Title: CRs to TS 34.123-3 (TTCN part, Cat. F) v.3.7.0, for approval

This document contains the CRs to TS 34.123-3 v.3.7.0. These CRs have been agreed by T1 and are put forward to TSG T for approval.

Test step name cb_DL_DPCH_AMR

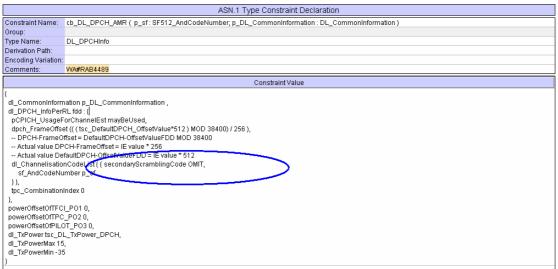
Reason for change The local change done @sic T1-041438 sic@ (omitting the secondary

scrambling code in the RAB setup message) has to be also done in the local

configuration (common constraint `icb_DL_DPCH_AMRî).

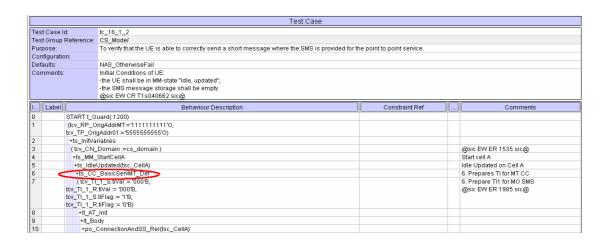
TI_1_S.tiVal := '000'B,			6. Prepare TI1 for MO SMS				
	R.tiVal := '000'B,			@sic EW ER 1985 sic@				
	3.tiFlag ≔ 1′B,							
	R.tiFlag := '0'B)							
	NT_Init							
	Body							
13 +pc	_ConnectionAndSS_Rel(tsc_CellA)

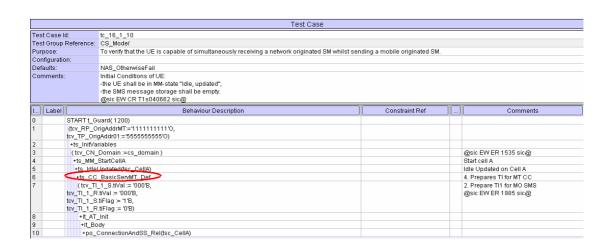
.tiVal := '000'B,			@sic EW ER 1985 sic@	
		tiFlag = 1'B,				
		.tiFlag := '0'B)				
11	+It_A					
12	+It_B					
13	+po_	_ConnectionAndSS_Rel(tsc_CellA)

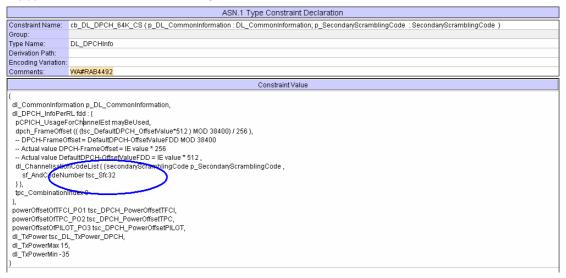
The change done in the RAB setup message @T1-041436 sic@ itsc_Sfc32î Reason for change

instead of `itsc_DL_DPCH1_ChC_64k_CSî in the RAB setup message in its_SendRB_SetUpDCH_64k_CS_Segmentedî and

its_SendRB_SetUpDCH_57_6k_CSî) must be also done for the local

configuration (constraint icb_DL_DPCH_64K_CSi).

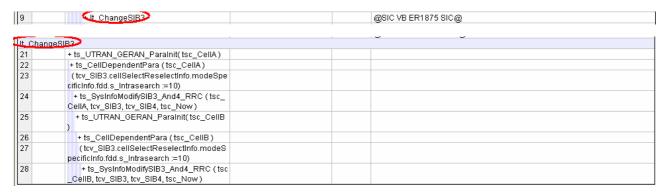
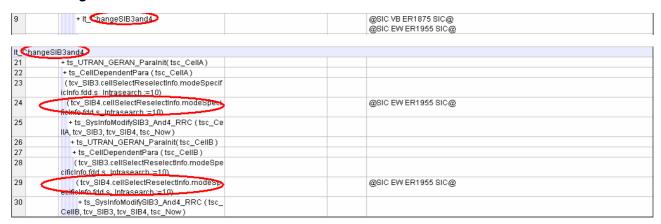
Test step	tc_9_4_2_4_2
Reason for change	In this test case one IE is changed in SIB3; as this IE is not omitted in SIB4, this SIB needs to be changed the same way.
Summary of change	test step lt_ChangeSIB3 renamed to lt_ChangeSIB3and4 (when used and when specified) change applied to SIB3 applied to SIB4 as well
Source of change	new change
